## ADDENDUM #3

Date: June 8, 2020

PACIFIC REGION  
PORT HARDY LOGISTICS DEPOT  
PORT HARDY, B.C.  
Project No: 8H500

drawing **Canadian Coast Guard Proposed Jensen Cove Site Topographic Survey Over Lots 22 & 23, Plan VIP45348 Port Hardy, BC**

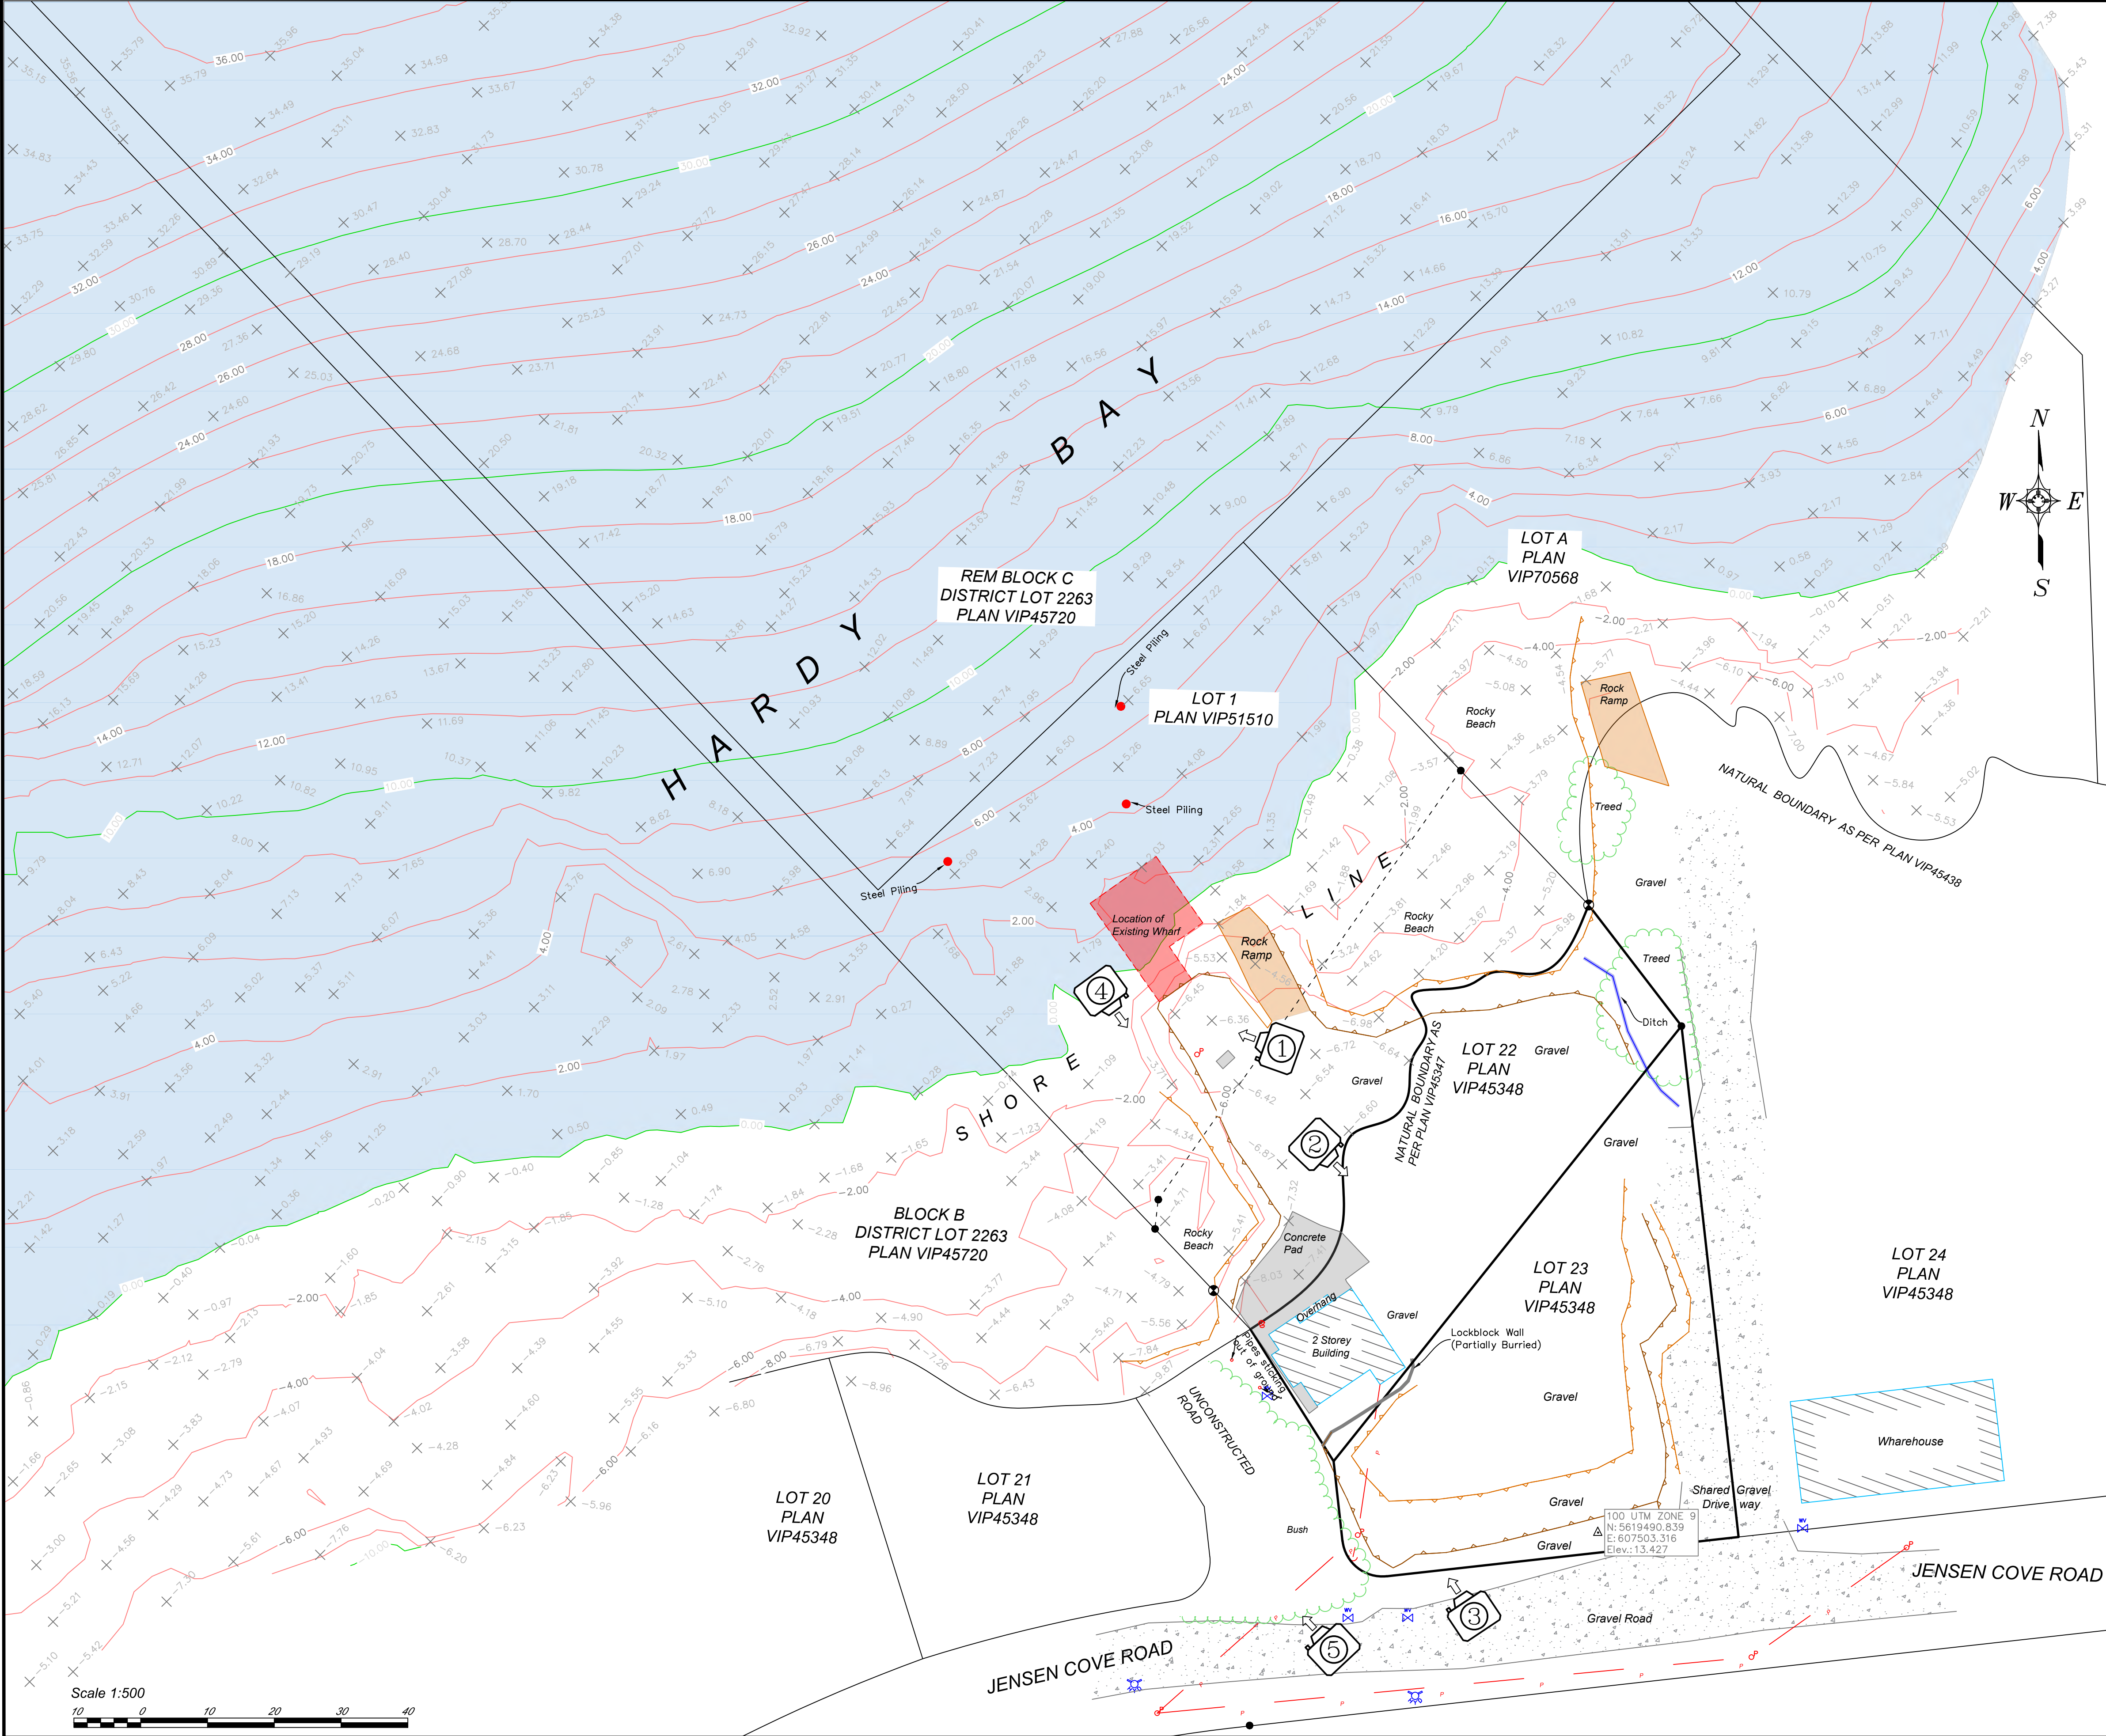
- A.35 Yes, all the existing marine infrastructure is required to be removed, including these piles.
- Q.36 Please provide a plan showing where these steel piles are located.

- A.36 See attached photographs showing the wharf and the piles. Also see the site bathymetry drawing that shows the location of the three large diameter piles.

Drawing title/Titre du dessin  
**ROOF FRAMING PLAN**

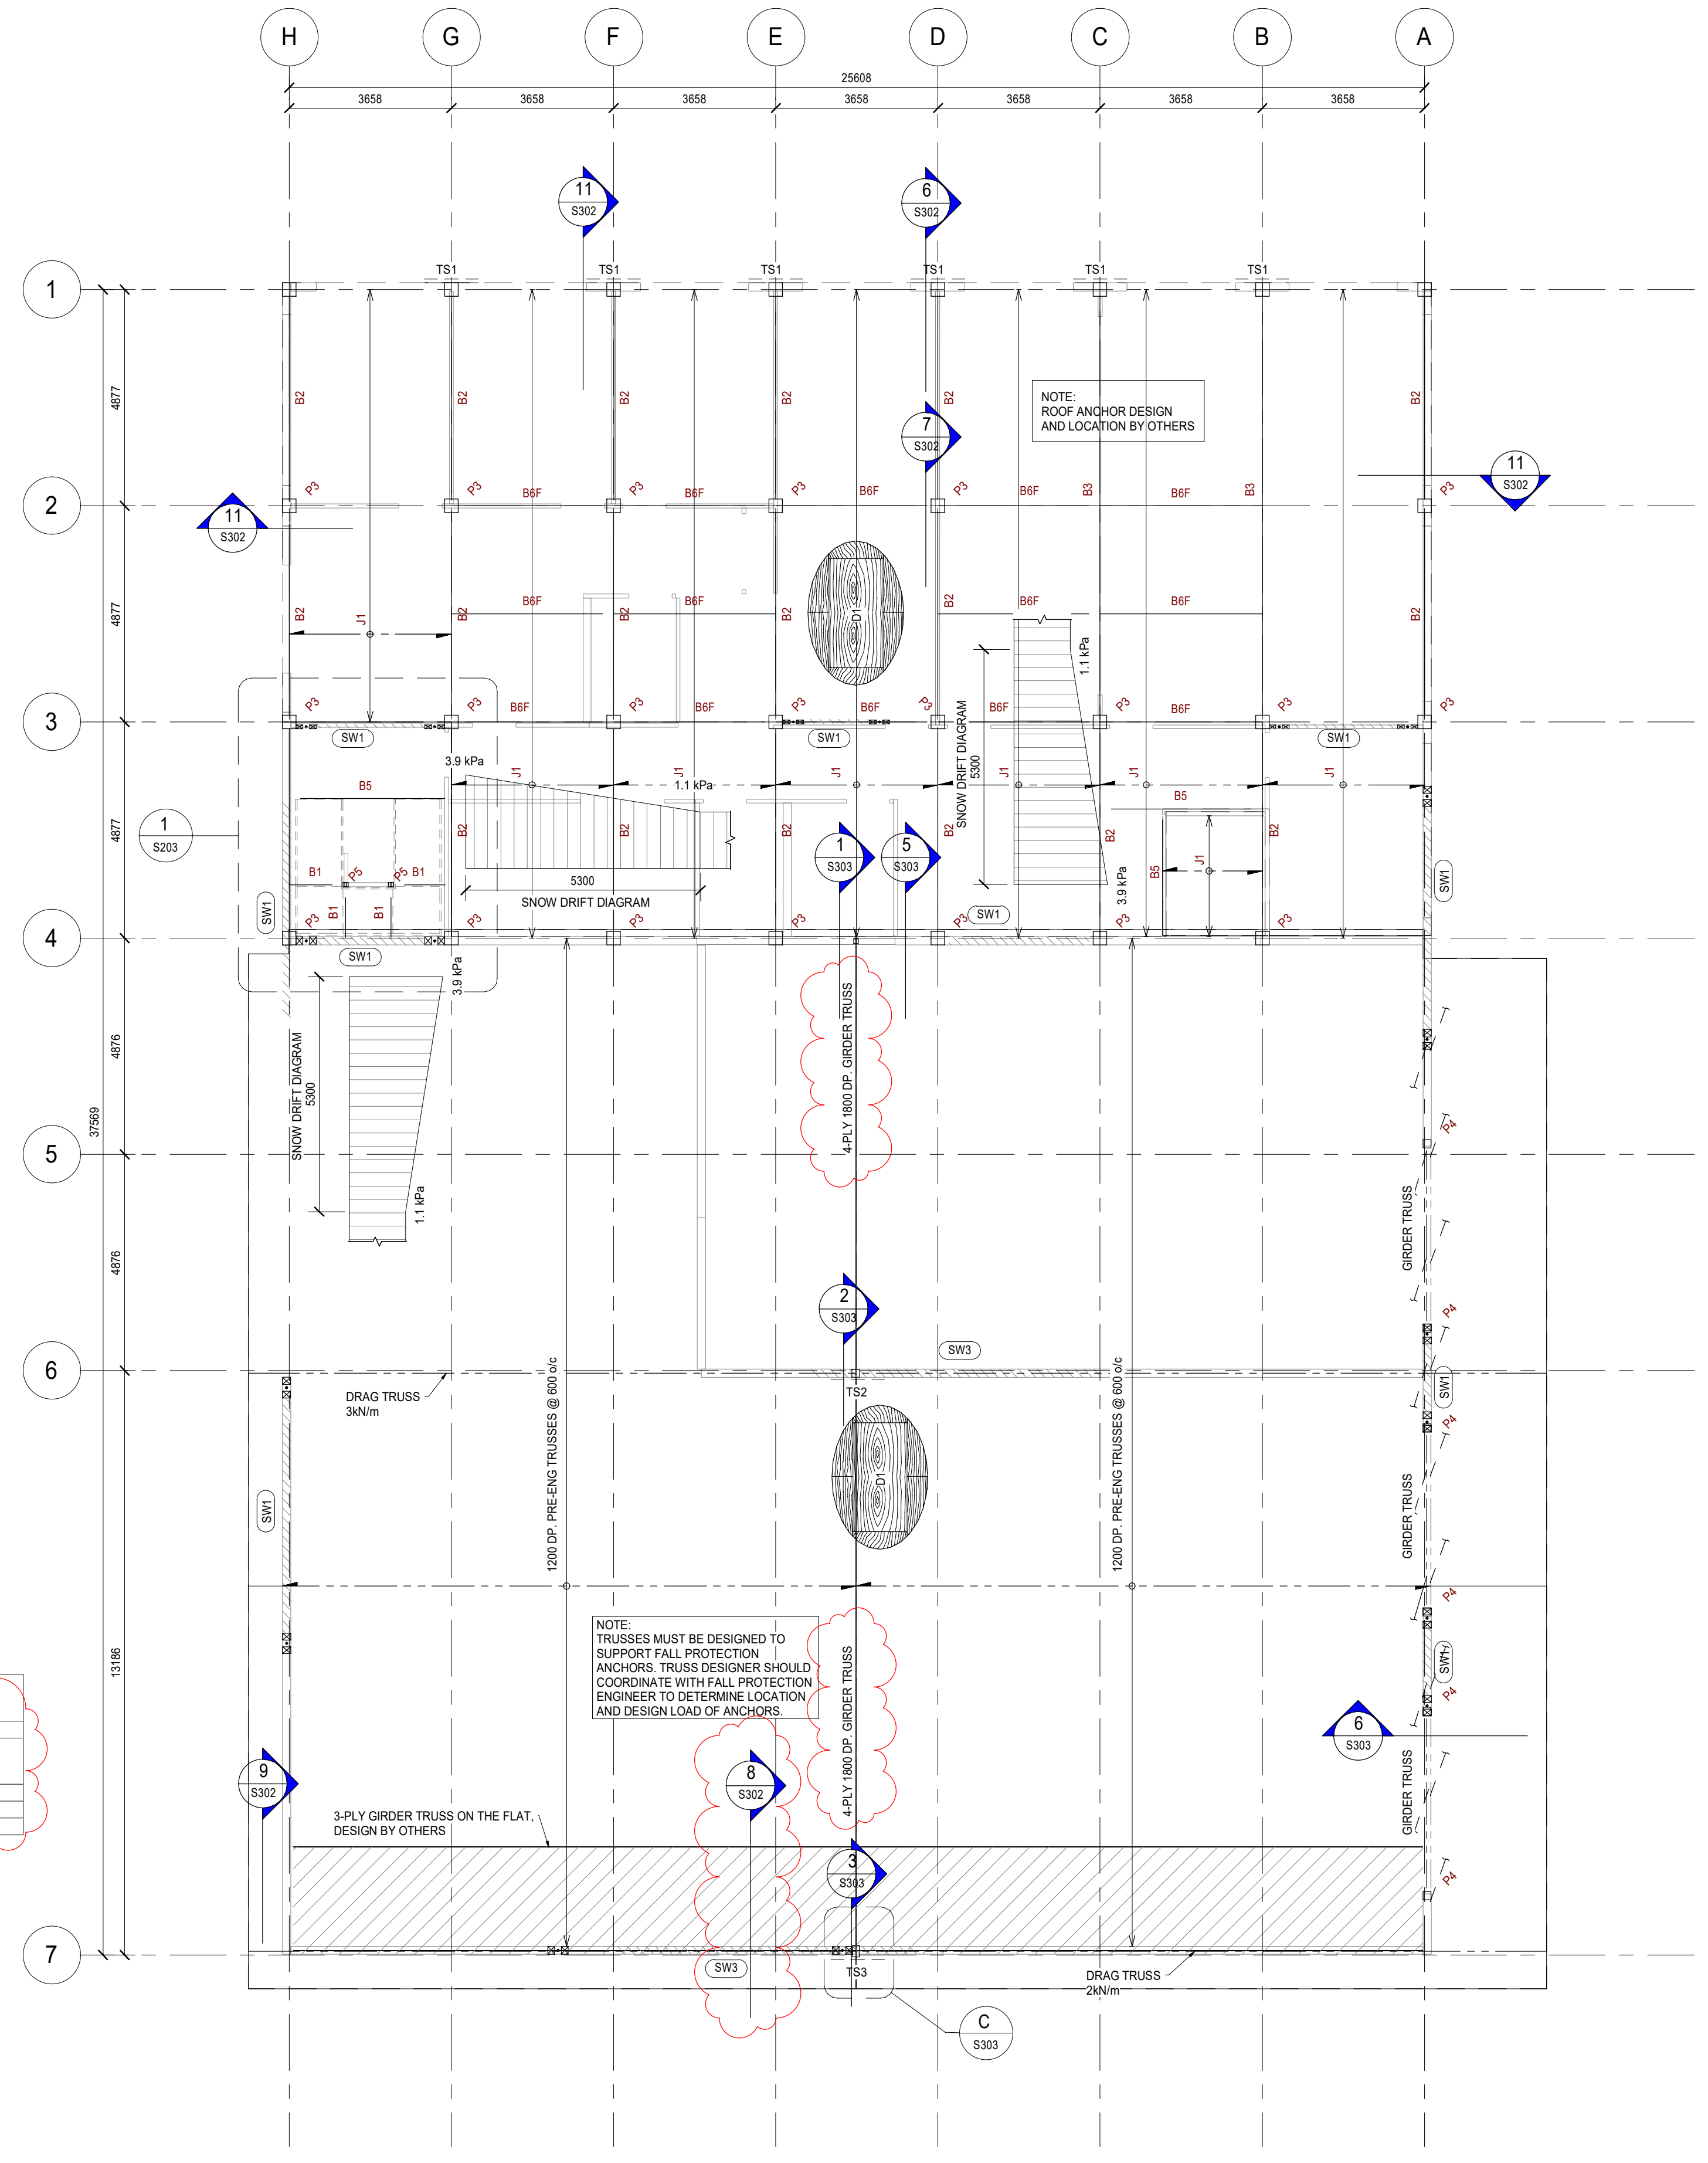
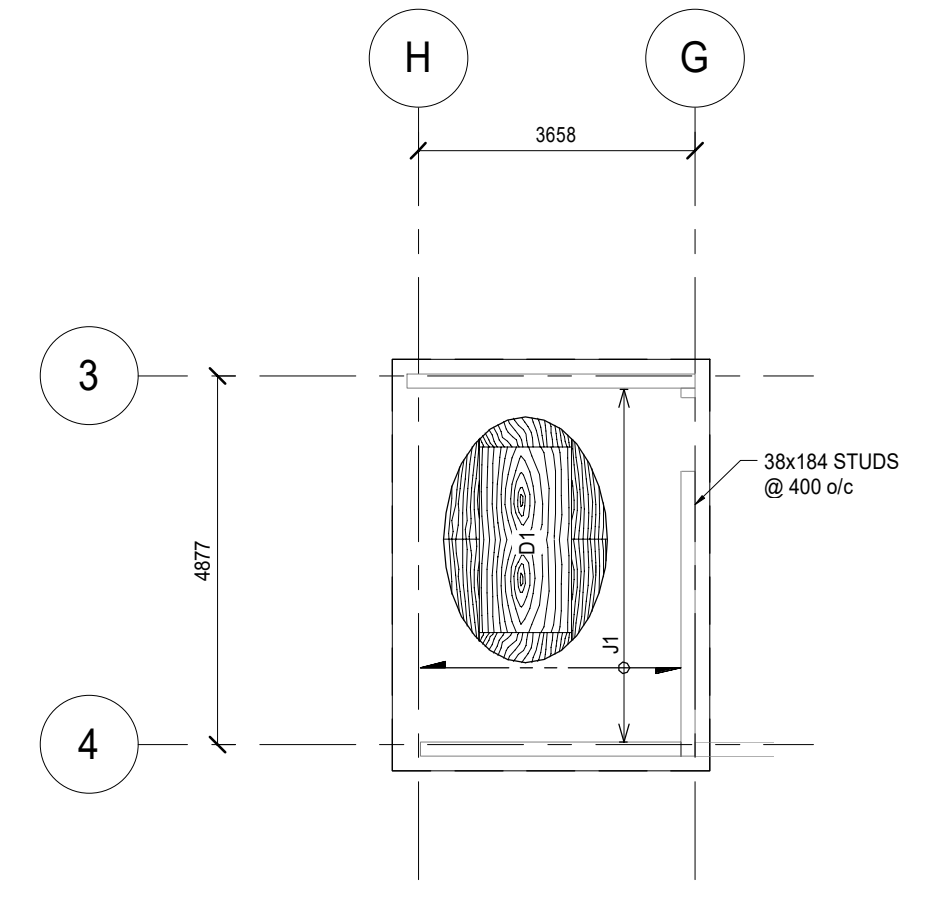
- Changed the depth of girder truss on GL D+.
- Added detail for achieving overhang on GL 7.
- Added embedment depths to hold-down/tie-down schedules.
